Airworthiness Directive Schedule

De Havilland DH82 Series (Tiger Moth)

26 April 2018

Figure 1 - De Havilland Design:

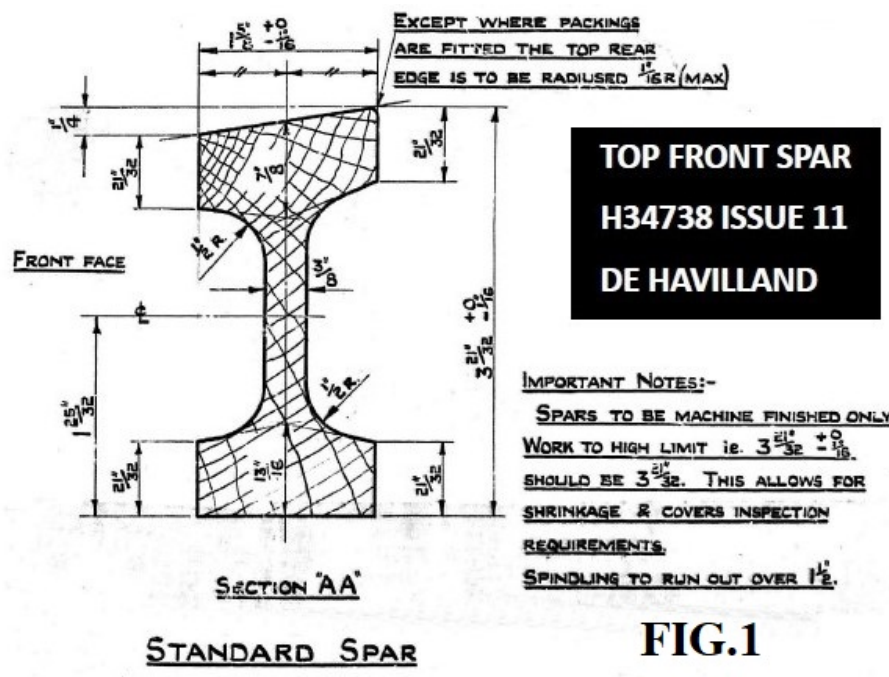
1. If an affected wing or aileron spar is found installed, then aerobatics or other flights involving high load factors, including flight in turbulent conditions are prohibited until requirement 2 of this AD has been accomplished.
2. If an affected wing or aileron spar is found installed, accomplish the following:
 - 2.1. If an affected aileron spar part number is found fitted, then conform the spar to the approved type design per the original de Havilland design, or replace the affected aileron spar, before further flight.
 - 2.2. If an affected mainplane/wing spar is found fitted, then inspect the forward and the aft faces of the affected spars in four places, and determine if the spar section properties (i.e. area, shape) conform to the approved type design per the original de Havilland design shown in Figure 1.

If the wing spar section properties conforms to the original de Havilland design shown in Figure1, then no further action is required, and the previous flight limitations can be removed.

If the wing spar section properties do not conform to the original de Havilland design shown in Figure1, then accomplish requirement 3 of this AD, before further flight.
3. Inspect the affected wing spar and compare the spar section properties with the Croydon spar profile shown in Figure 2.

Figure 2 – Croydon Spar Profile:

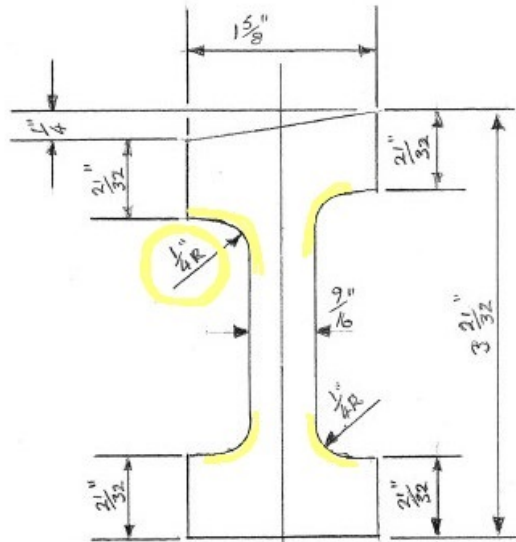
If the wing spar section properties (minimum spar web radius and dimensions) are found not less than that shown in Figure 2, (i.e. the inside radii of the spar cut-

outs are found not less than 0.25 inches as shown in Figure 2), then no further action is required, and the previous flight limitations can be removed.

If the wing spar section properties (minimum spar web radius and dimensions) are found less than that shown in Figure 2, (i.e. the inside radii of the spar cut-outs are found less than 0.25 inches as shown in Figure 2), then remove the affected spar from service, and replace with a serviceable part, before further flight.
